UPDATE CHANGE NOTIFICATION # UN16490Generic Copy

TITLE: Update to the Final Notification of Transfer of Low Capacitance TVS (Transient Voltage Suppressor) Array products from ON Semiconductor COM1 Fab in Phoenix (USA) to ON Semiconductor Fab2 in Oudenaarde (Belgium).

AFFECTED CHANGE CATEGORY(S): Change to the Description and Purpose (Addendum);
Change to Affected Part List

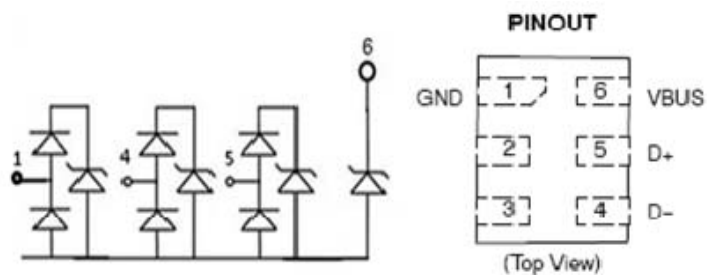
In order to facilitate certain parametric improvements during the transfer a change was made in the part schematic (shown below). This change is transparent in the performance of the part in the intended application, and the device pin out remains the same. However, the change may be noted during pin to pin ICT testing.
